Rezoning Transportation Analysis

Petition Number: 2023-034

Date	Description
06-28-23	First Review (TM)
07-28-23	Second Review (TM)
08-21-23	Trip Gen. Update (TP)
10-26-23	Third Review (TM)
11-27-23	Fourth Review (ME)
12-20-23	Fifth Review (TM)

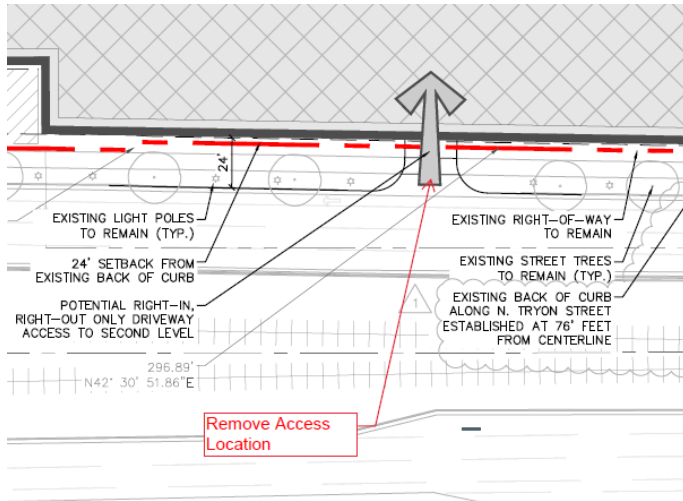
3. ~~NEW COMMENT FROM 10-26-23:~~ Remove Access point that was added to Tryon Street.
